RE: 208 North Aberdeen Avenue Townhouses

Gannett Fleming, Inc. has completed a review of the Preliminary Land Development for compliance with the Radnor Township Code. We have reviewed the plans based on the contents of the C3 Zoning Amendment (to allow townhouse developments in certain areas of the C-3 district) that has not yet been approved by the Board of Commissioners. These Plans were also reviewed for conformance with Subdivision and Land Development, and other applicable codes of the Township of Radnor.

MEMORANDUM

Reference: 208 North Aberdeen Avenue Townhouses
Final Minor Land Development Plan Review #2
Radnor Township, Delaware County, PA
G&A #20-06064

TREE PROTECTION DETAIL

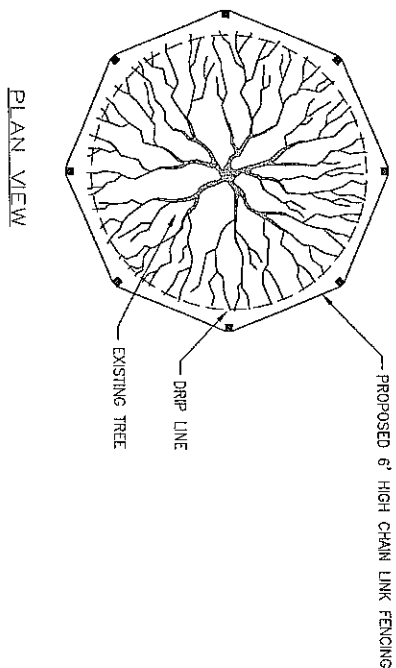
5. The attached tree protection detail from Rockwell and Associates must be added to the plan.
